**STAFF RECOMMENDATION**  
**150 Windsor Drive**  
**August 16, 2017**

**Application:** New construction-addition  
**District:** Belle Meade Links Triangle Neighborhood Conservation Zoning Overlay  
**Council District:** 23  
**Map and Parcel Number:** 13001009100  
**Applicant:** Jeff Steele, architect  
**Project Lead:** Robin Zeigler, robin.zeigler@nashville.gov

<p><b>Description of Project:</b> Add on to an existing non-contributing home.</p> <p><b>Recommendation Summary:</b> Staff recommends approval with the condition that Staff review final materials for windows, masonry, cladding, roofing and porch. With this condition, the project meets the design guidelines for new construction.</p>	<p><b>Attachments</b> <b>A:</b> Photographs <b>B:</b> Site Plan <b>D:</b> Elevations</p>
---	--

## ARCHITECTURAL SITE PLAN

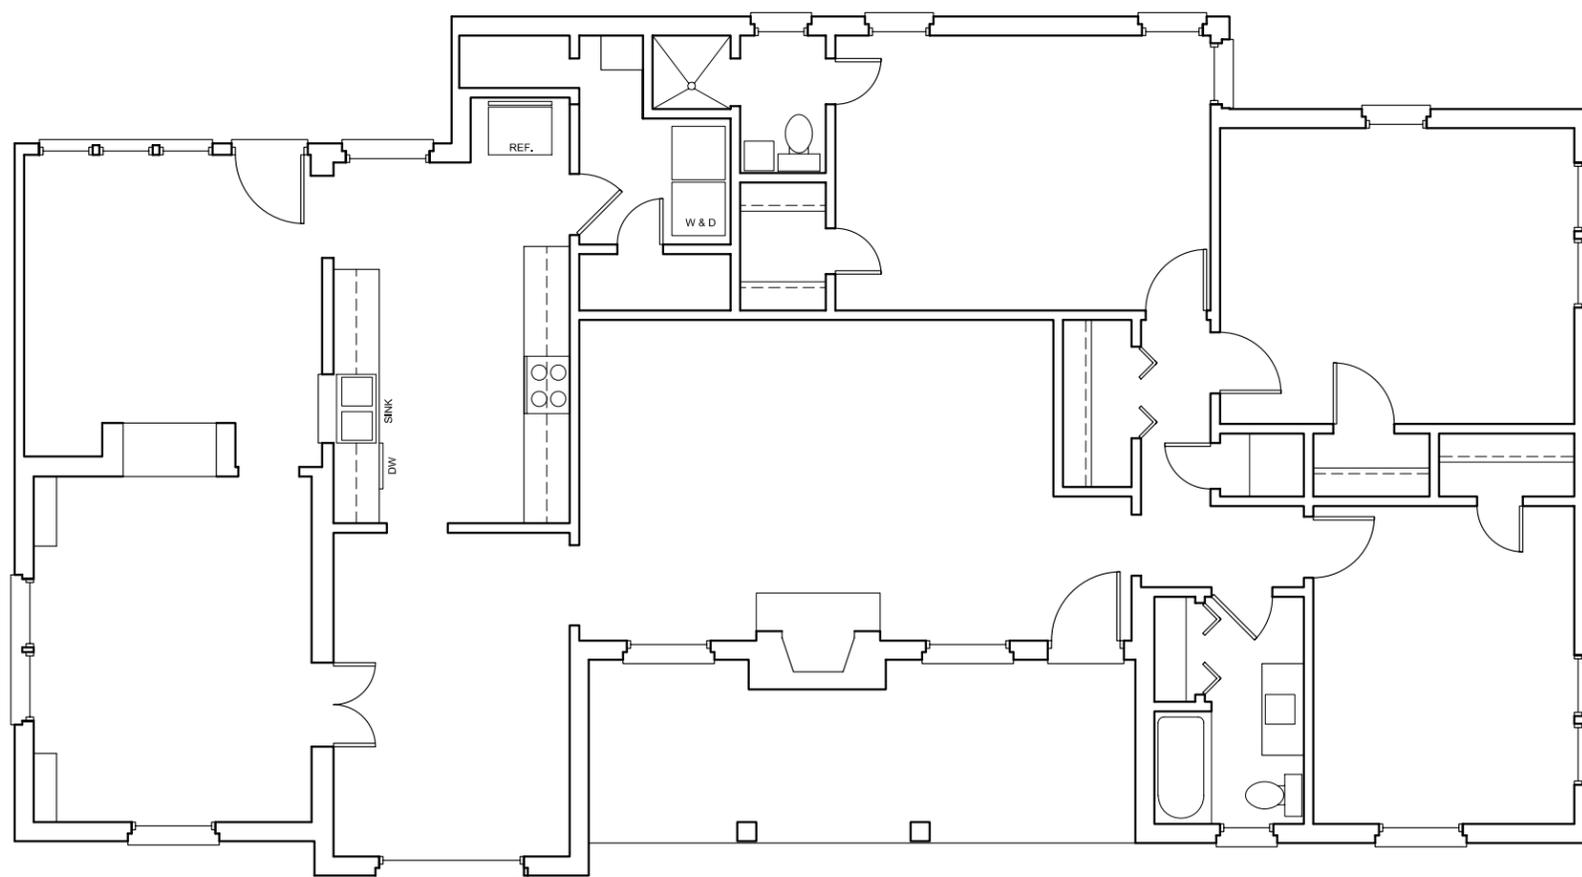
Setback & Rhythm of Spacing: The front and side setbacks will not change. The rear setback will be approximately 40' at the closest point, which more than meets the historic context and the bulk standard requirements. The project meets section II.B.1.c.

**EXISTING FIRST FLOOR PLAN**

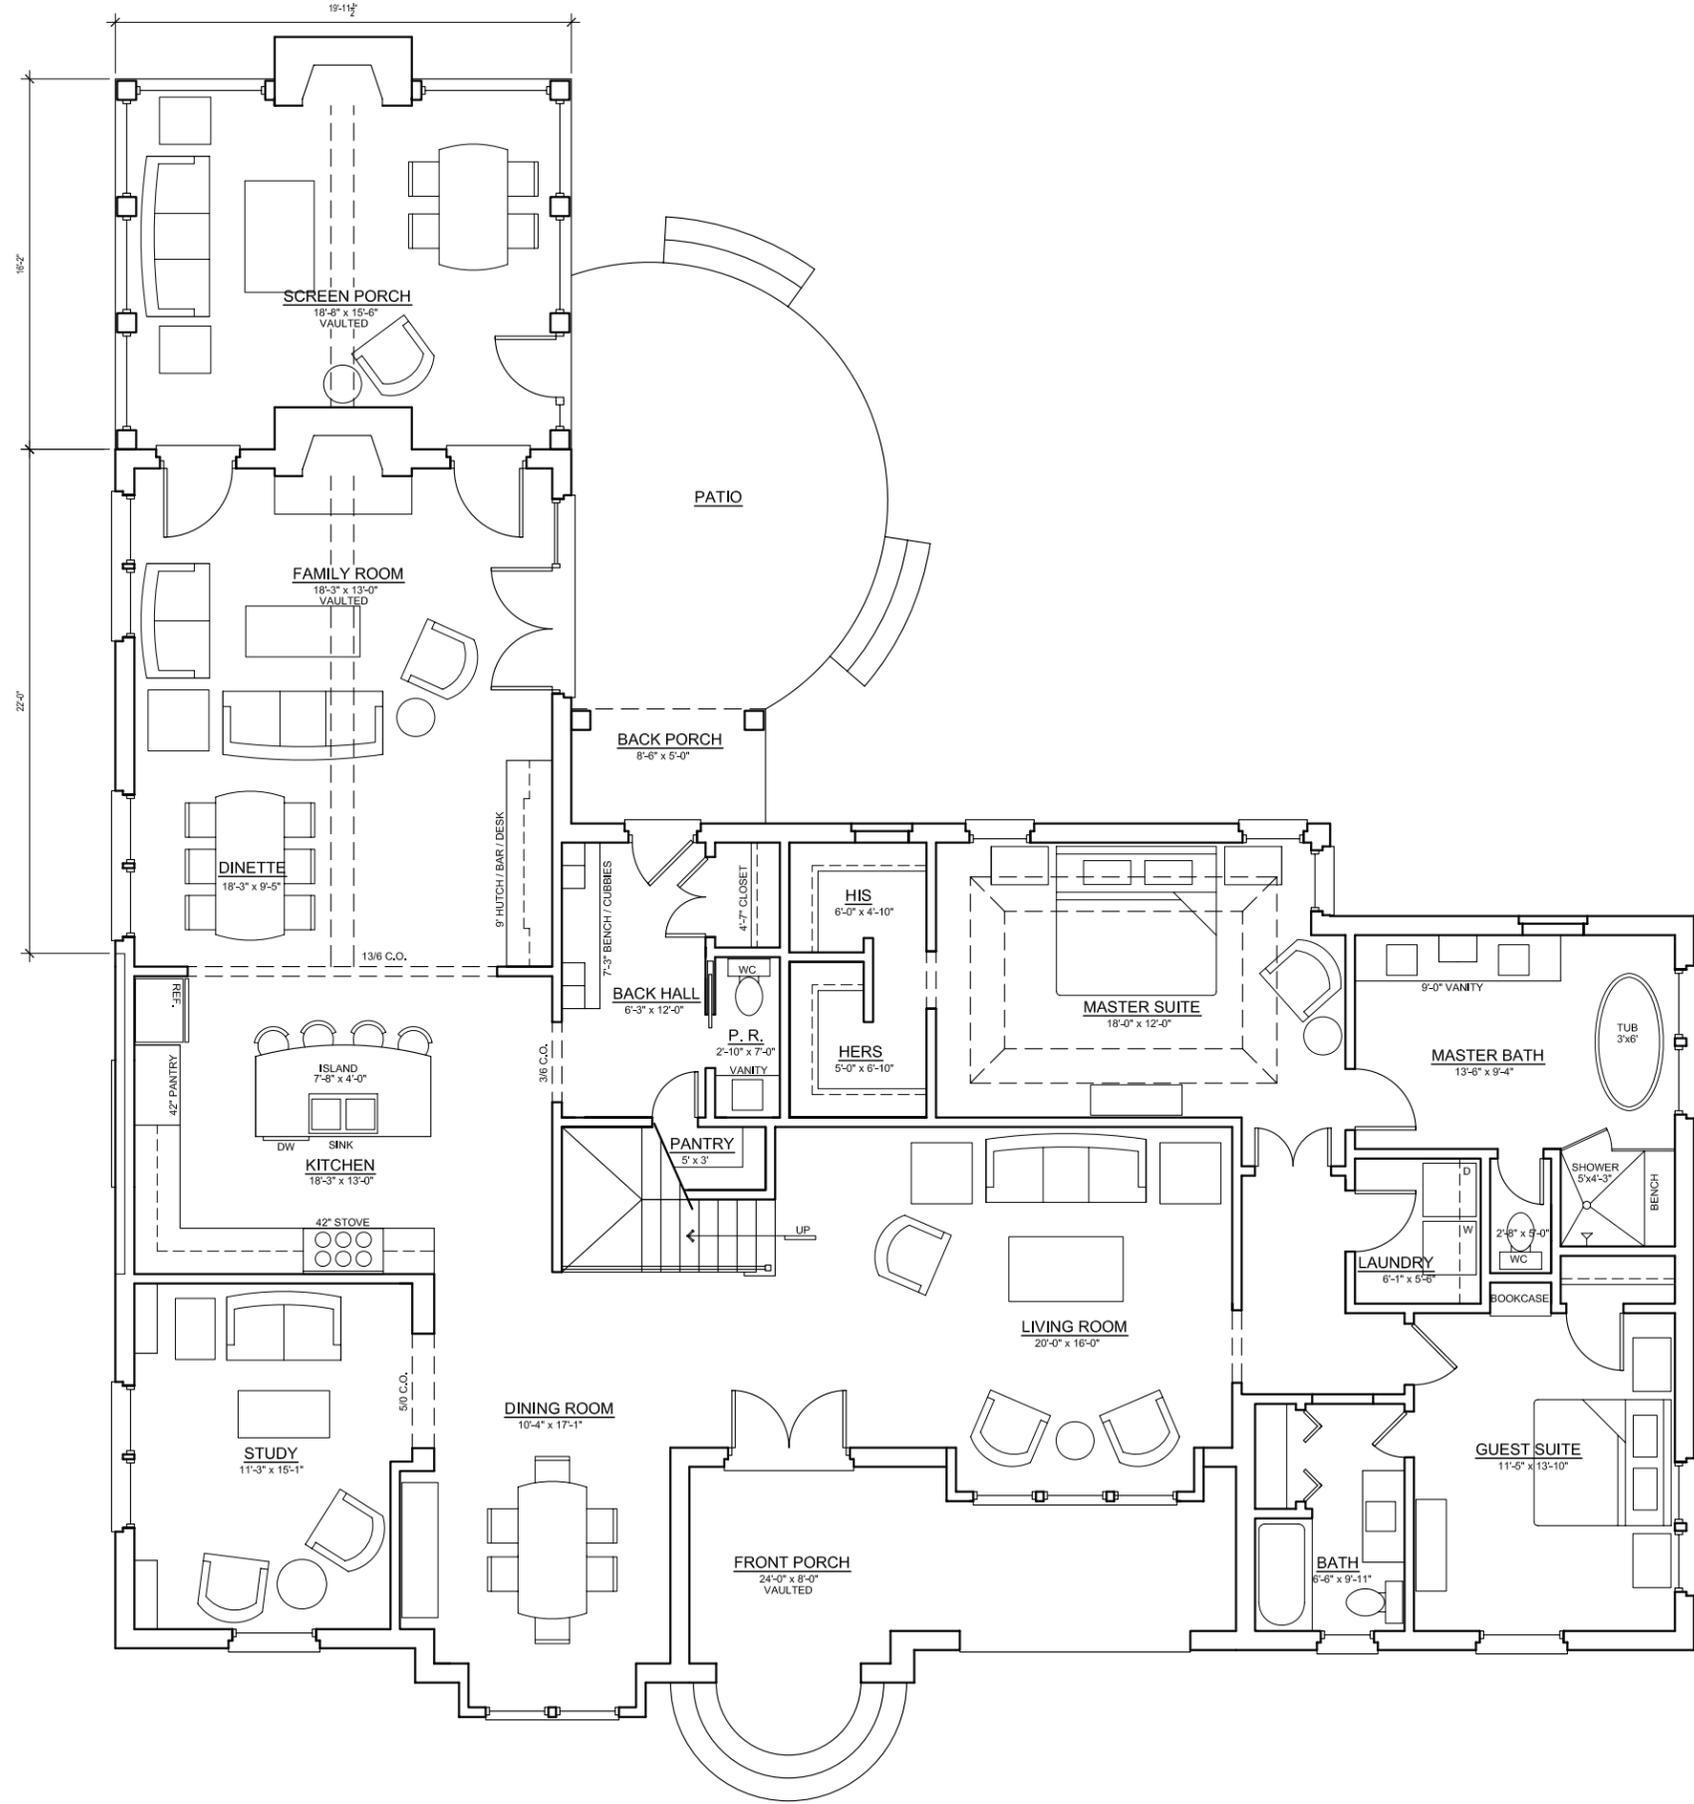
Demolition includes removal of the roof and chimney, portions of the front wall to accommodate a bay and different sized window openings and portions of the rear wall. Staff finds the demolition to be appropriate based on the argument previously for the building being non-contributing and because the alterations will be a better fit for the neighborhood than the current design of the building. Staff finds that the proposed demolition meets section III.B.2.b of the design guidelines.

**REMODELED FIRST FLOOR PLAN**

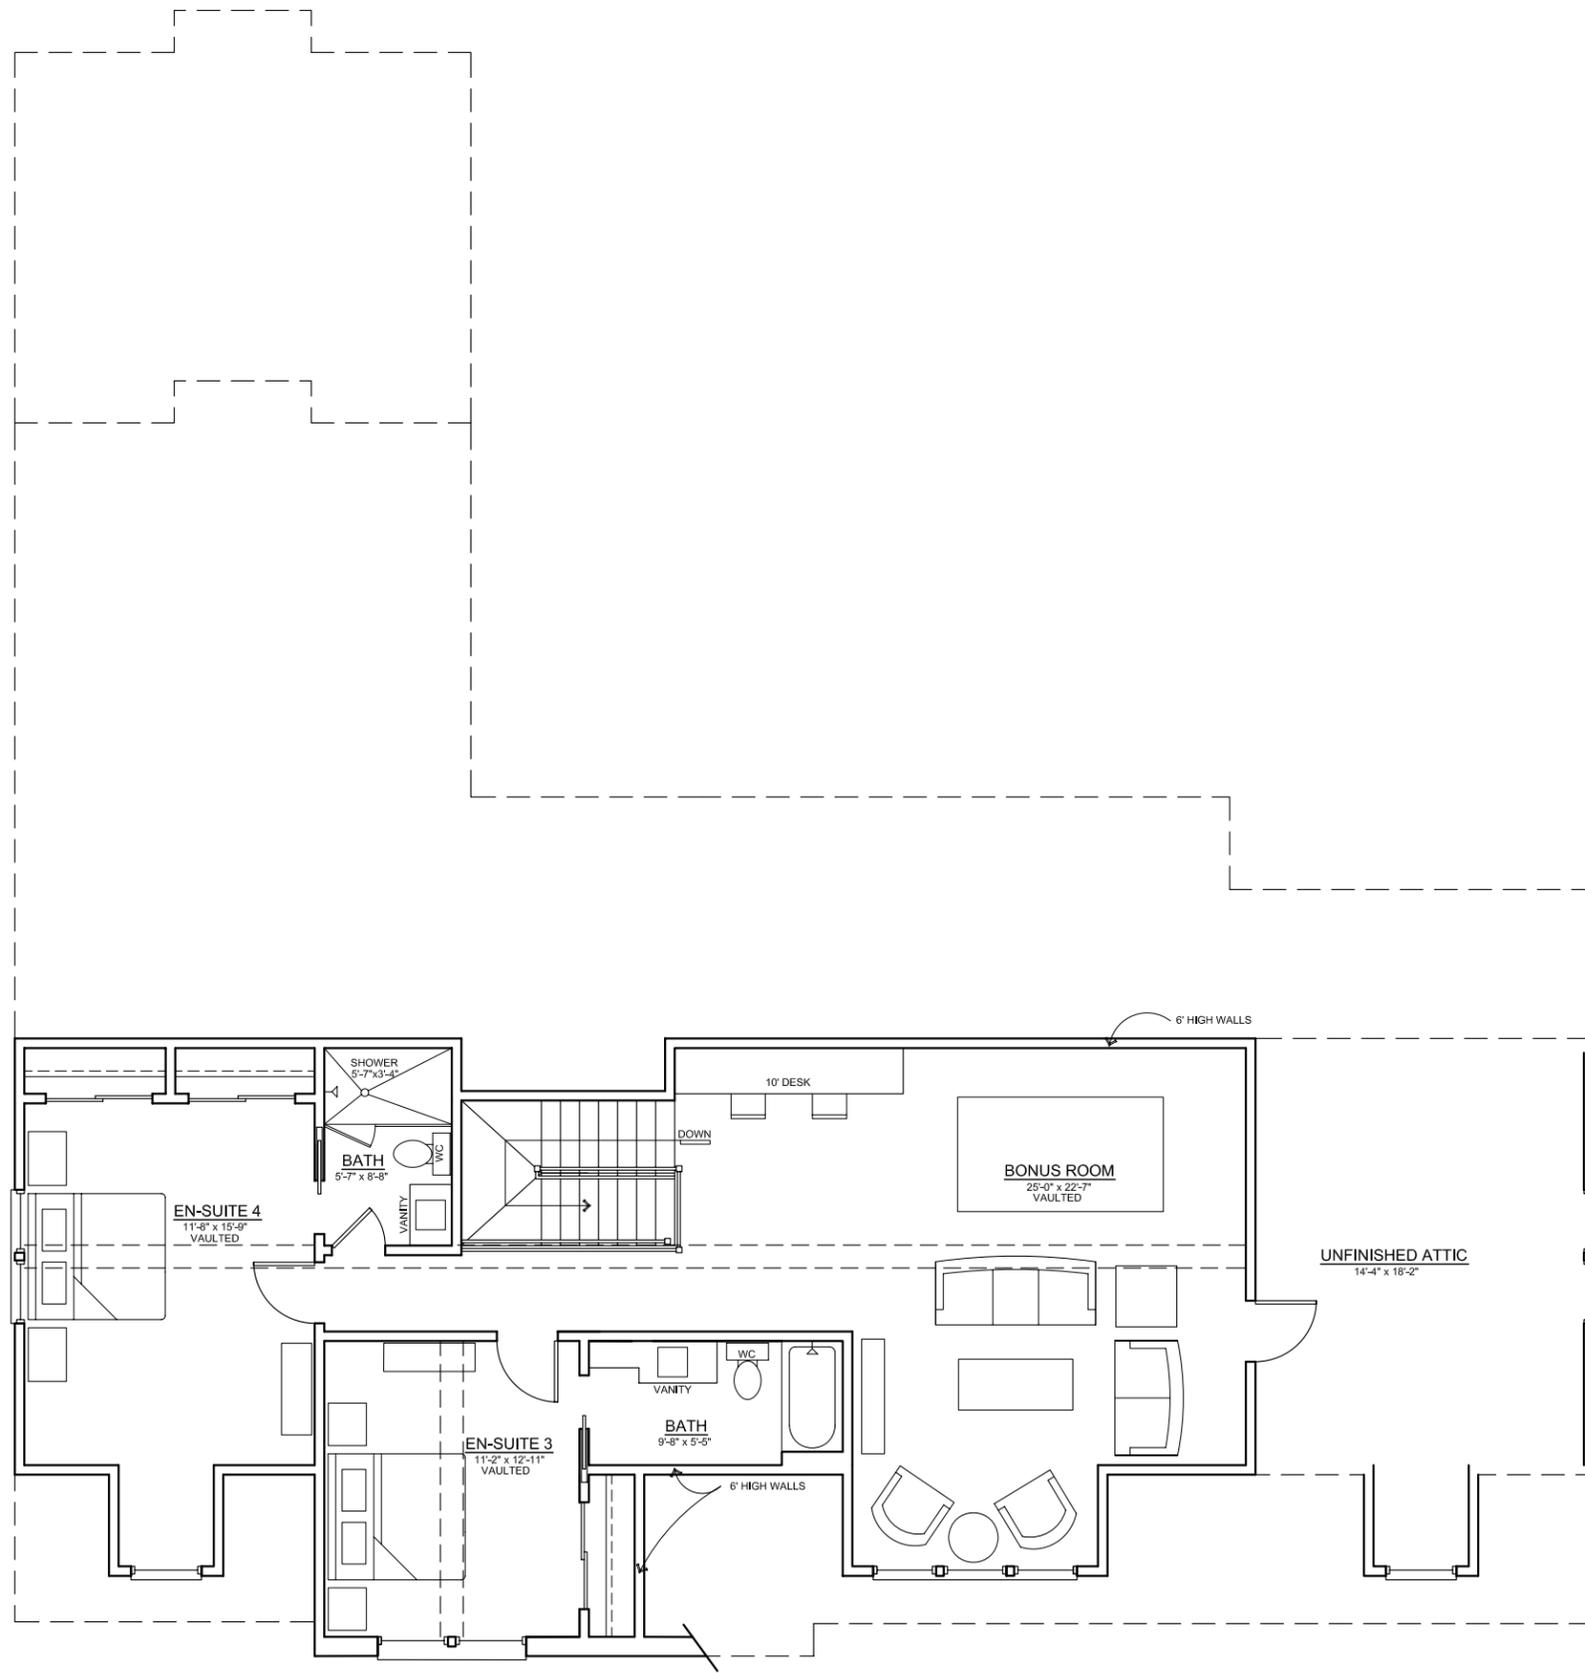
Orientation: The orientation will not change. The exact entrance will be moved slightly; however the building will still be oriented to the street with a recessed, arched entry typical of Tudor Revival styles found in this district. The project meets section II.B.1.f.

Appurtenances & Utilities: The existing location of the HVAC will move southeast and will remain on the rear façade. The existing walkway will be extended to accommodate the new entrance location. No other alterations to the site were noted. The project meets section II.B.1.i.

**NEW SECOND FLOOR PLAN**

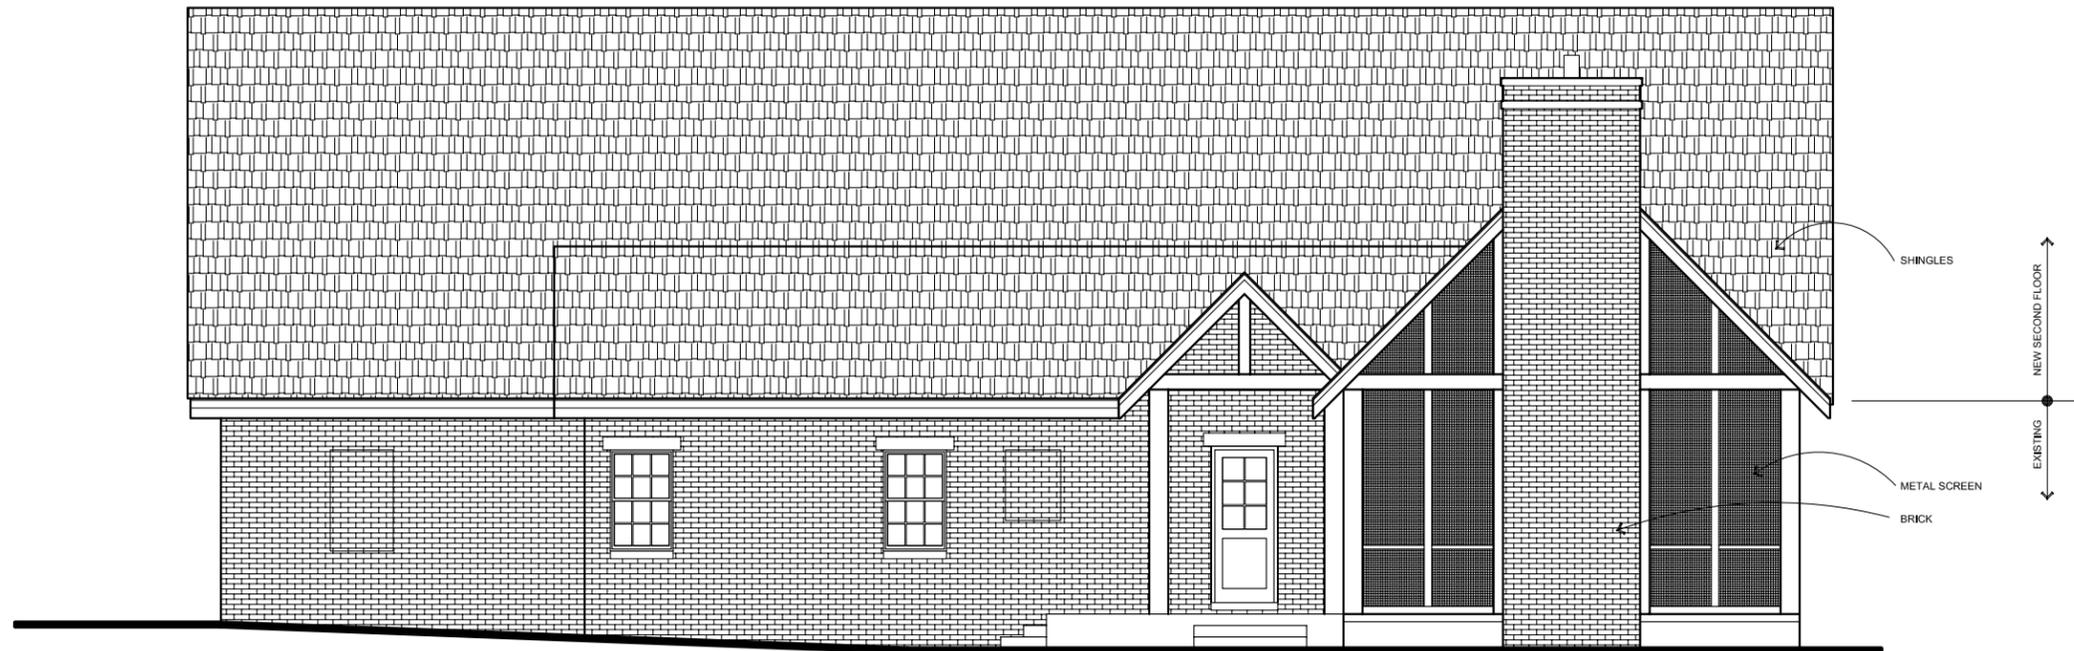
The new version of the existing house will be approximately twenty-seven feet, ten and a half inches (27' 10 ½") tall from front grade at the tallest point. The historic context ranges between twenty one feet and twenty-six feet (21'-26') tall from grade. Although the home is slightly taller than the primary context, it is within keeping with a few outliers that are taller than the primary context. Staff finds the proposed height to be appropriate because the amount over the primary context is minimal, the portion of the building that reaches the maximum height is minimal, and the overall roof form and massing minimize the perception of the height.

Roof form: The proposed roof form is a 12/12 pitch side gable roof with shed roof dormers. The form is typical of the district. The project meets section II.B.1.e.
